ADDENDUM NO.: 4

Description: Furnish, Deliver, and Install AV Equipment

Project: CCNY Aronow Theater

TA-801

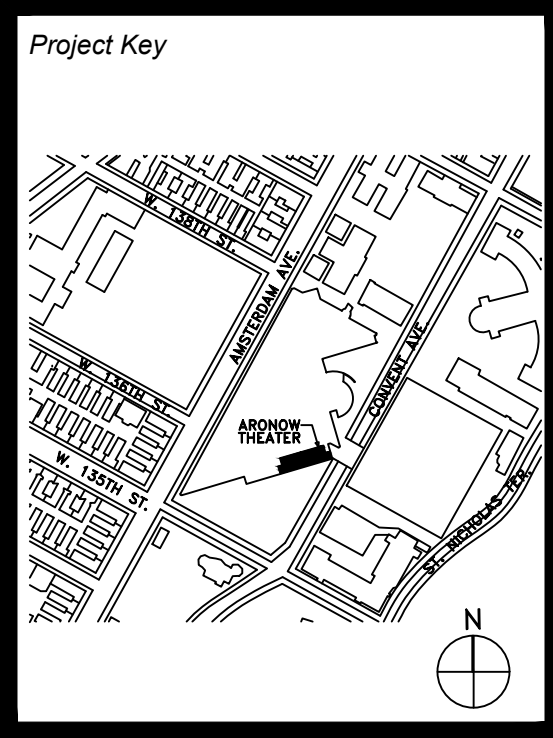
Q2. Drawing TA-801, Item 6-41 – This shows a Vaddio 999-9595-000 (AV Bridge). The OneLINK Bridge for Vaddio HDBaseT cameras does not provide multiple HDMI I/O as illustrated. Please confirm the correct configuration.

Q3. Drawing TA-801, Item 6-1 – This references a Q-SYS camera with a “quick link” to HDMI. The Q-SYS camera is not HDBaseT, so it is unclear what device is intended for conversion. Please confirm the required configuration.

A2. See updated TA-801, specification and bill of materials (BOM).

A3. See updated TA-801.
